BOARD OF COMMISSIONERS
AGENDA
Monday, March 11, 2019 - 6:30 PM

RE: 415 Maplewood Avenue – Preliminary Subdivision Plan
David Semerjian Builders – Applicant

Preliminary Subdivision Plans – 415 Maplewood Avenue

Plans Prepared By: Edward B. Walsh & Associates, Inc.

PRELIMINARY LANDSCAPE PLAN

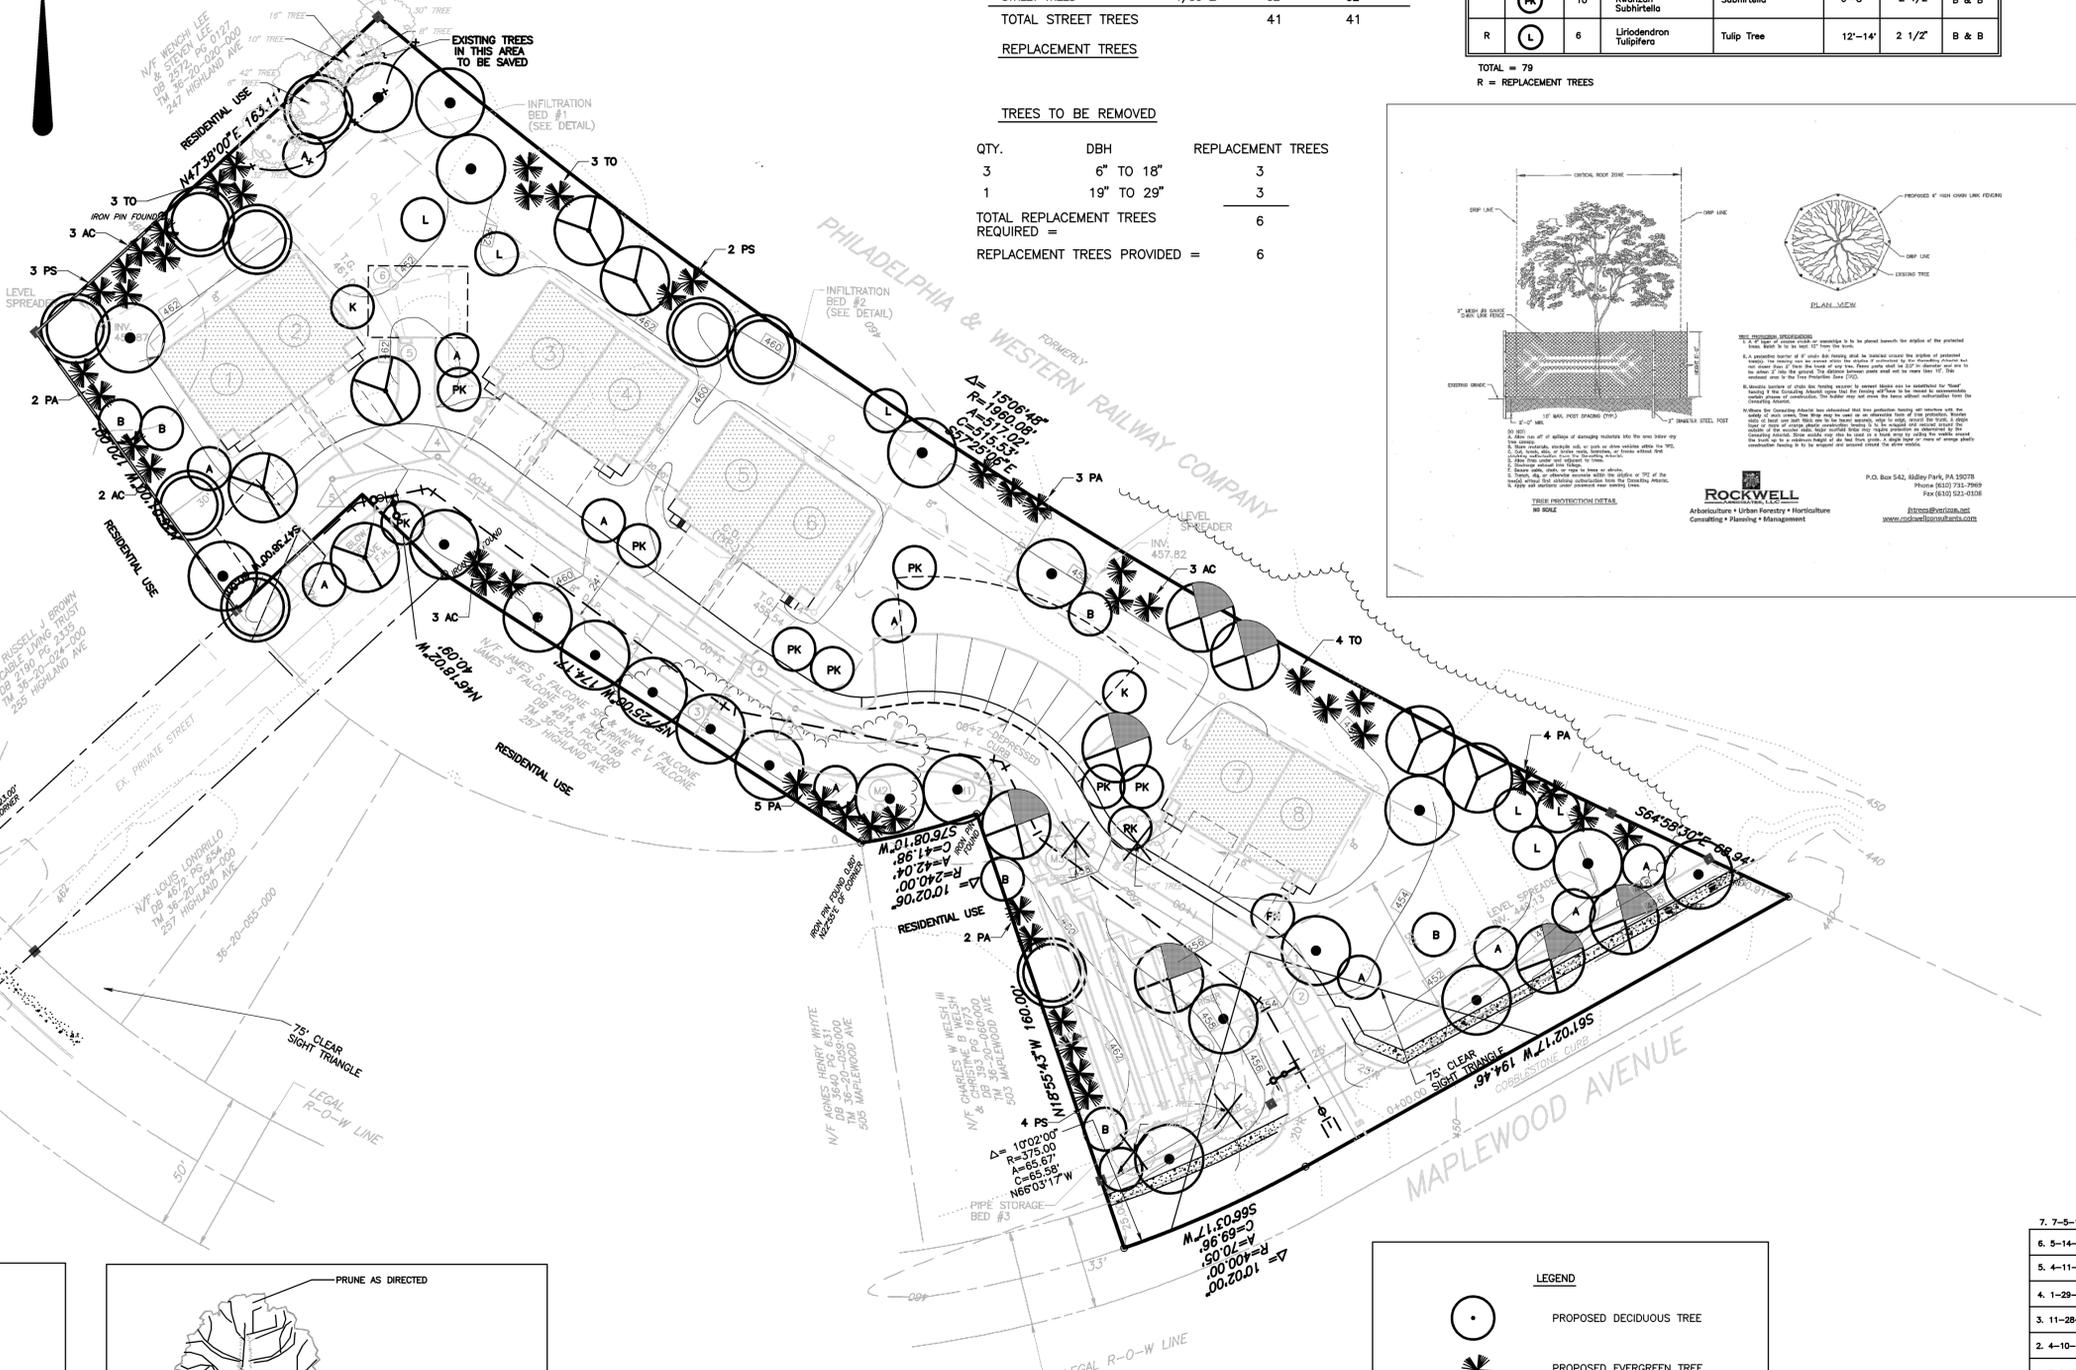
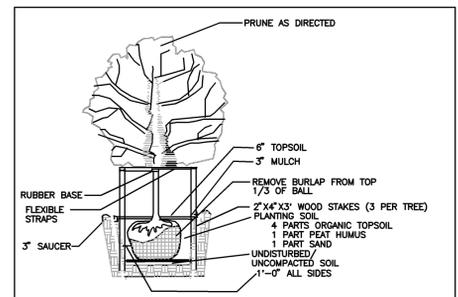
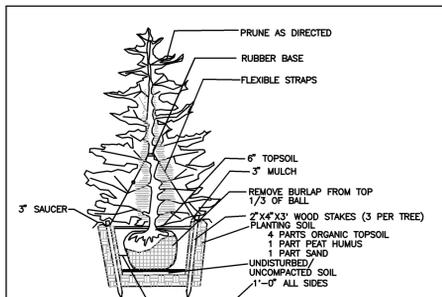
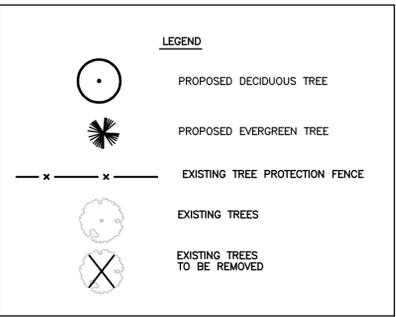
10. §255-38 – Sheet 12 of 18 indicates that there will be plantings located in the existing private street and interfering with the proposed 12' emergency access. This must be revised.

7. §255-38 – Sheet 12 of 18 indicates that there will be plantings located in the existing private street and interfering with the proposed 12' emergency access. This must be revised.

8. §255-38.H – All street trees provided on the plans must be in accordance with this section. There are trees listed on sheet 12 of the plans that are not listed in this section. This must be revised or a waiver requested. The applicant has indicated that due to the changes of the plan, they are required to go back to shade tree.
